Comprehensive Development Plan Fitchburg Minerals Property

South of Lacy Road & East of Fitchrona Road
City of Fitchburg
Dane County, Wisconsin

RE:
Fitchburg Minerals
Comprehensive Development Plan
Response to Evaluation Comments
Received July 2021

PLAN COMMISSION MEMO 06/29/2021

**CONCEPTUAL SITE, UTILITY
 AND PHASING PLAN**

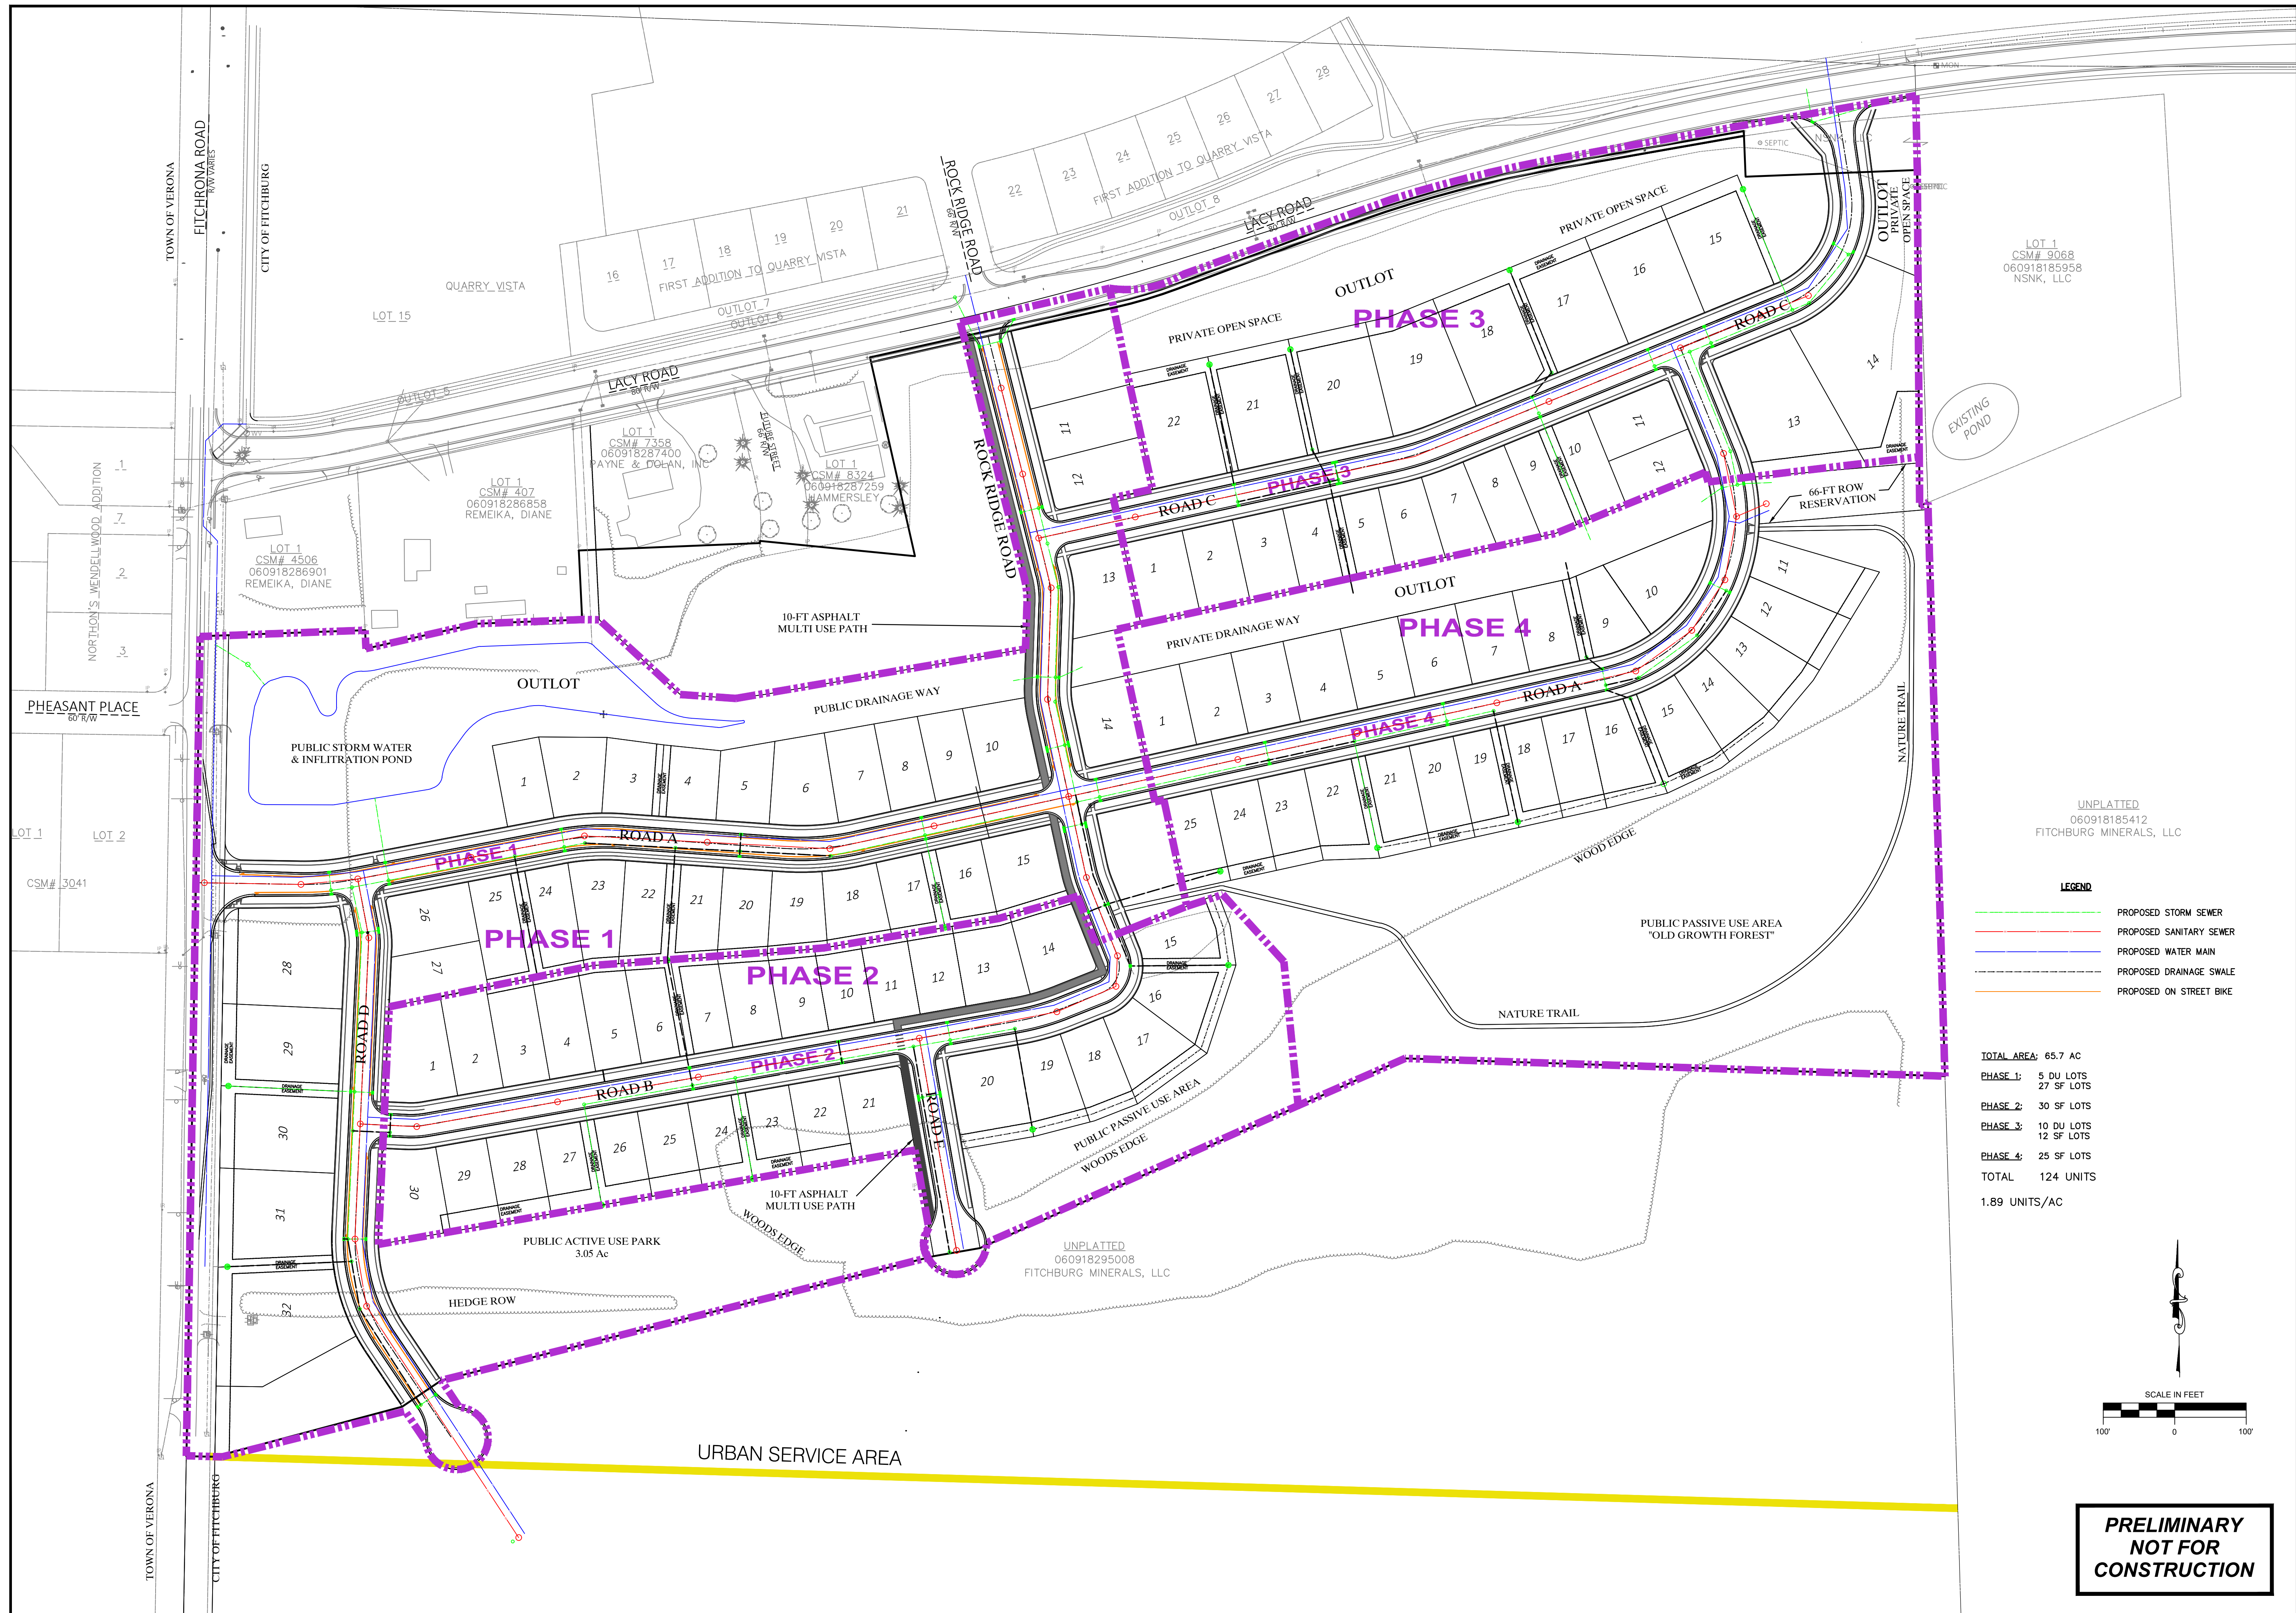
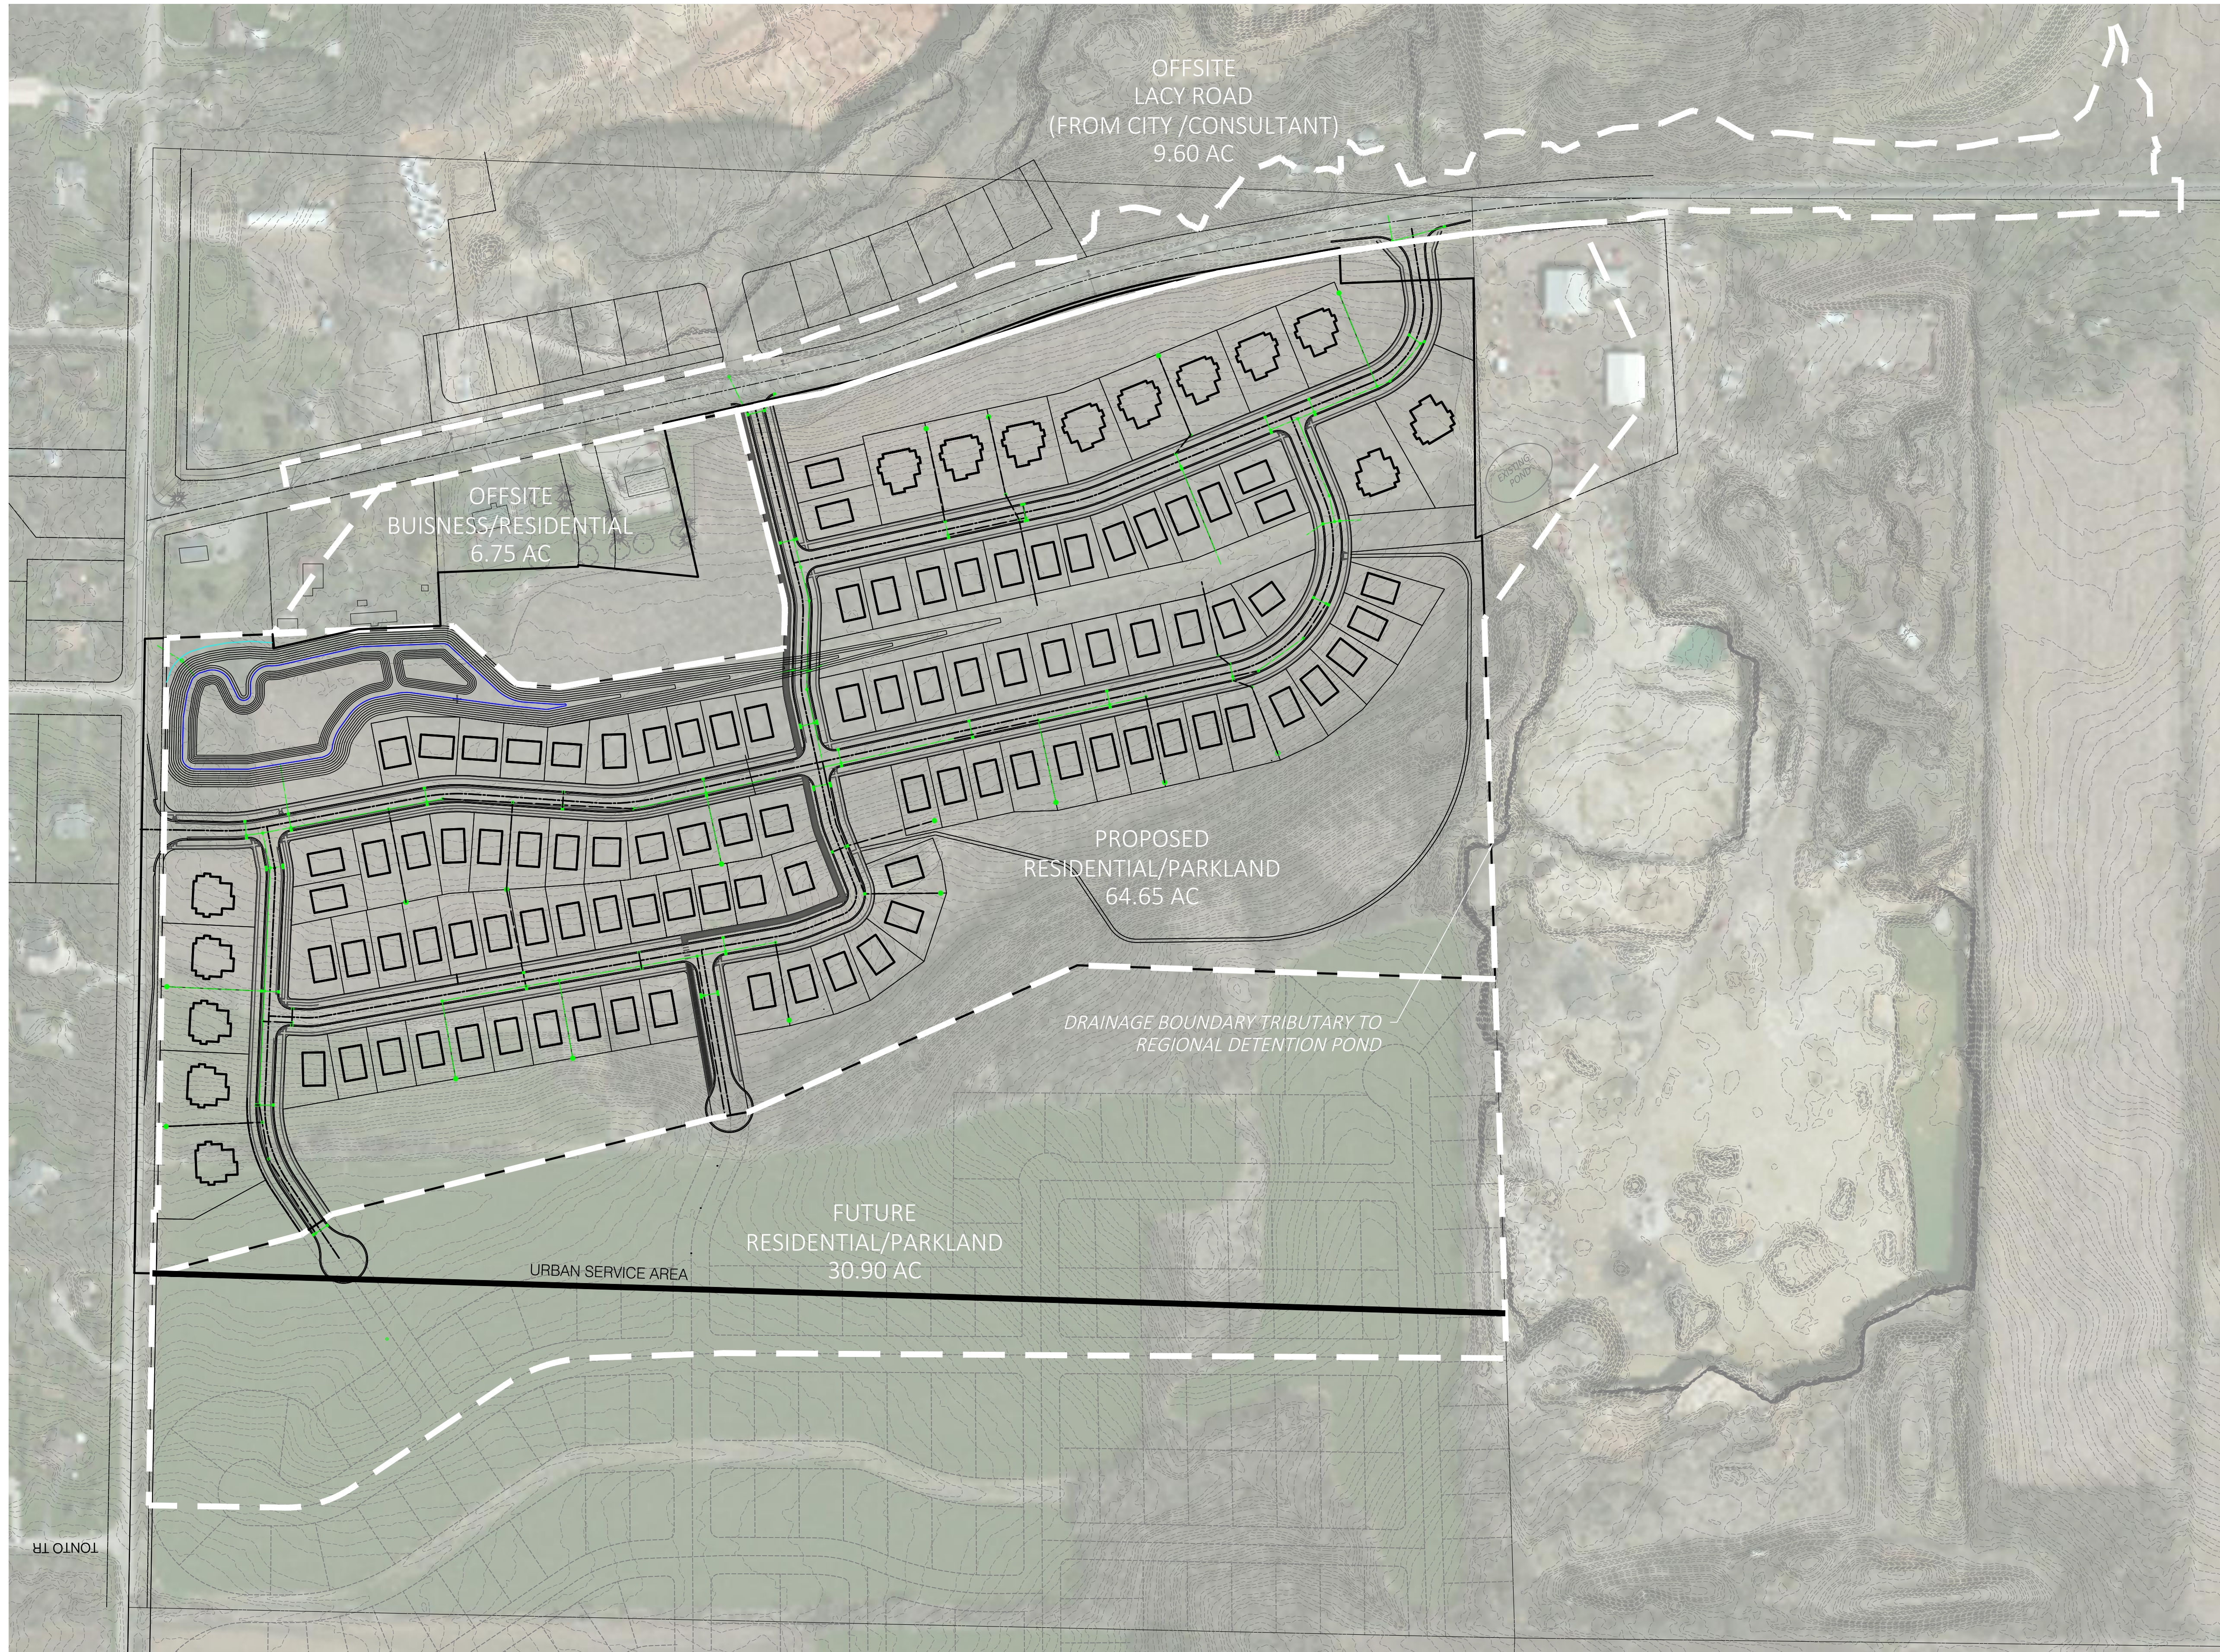
- The streets labels are inconsistent between Exhibit 3 and the Plan & Profile documents.
 - Street labels have been coordinated on all exhibits.

3. Please indicate/correct the following in Section 3.4 and Exhibit 3:
 - The water main on Roads C and D shall be loop through the future outlot for future development (lot size listed as 130,287 SF) and ultimately connect to the water main on Lacy Road.

- 8-inch minimum sized water mains shall be installed and looped within the plat as directed by the City. Final sizes to be determined by the City during the planning process.

- Provide proposed water and sanitary usages for this development.
 - a. As the design and entitlement approvals proceed, the details of these comments will be reviewed and resolved with public works.
